MCP2140 Rev. A Silicon/Data Sheet Errata

The MCP2140 Rev. A parts you have received conform functionally to the MCP2140 device data sheets (DS21790**A**), with the exception of the anomaly described below.

FIGURE 1: CIRCUIT FOR AN INTEGRATED OPTICAL TRANSCEIVER

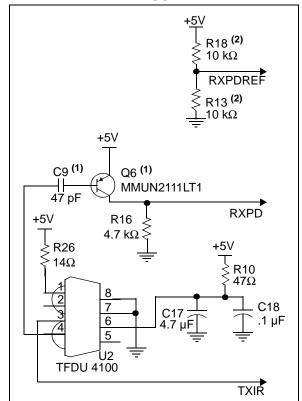
1. Figure 2-12 should be corrected to the circuit shown in Figure 1.

Note 1: These components are used to control the width of the TFDU 4100 RXD output signal

2: These components are used to set the reference voltage that the RXPD signal needs to cross to detect a bit.
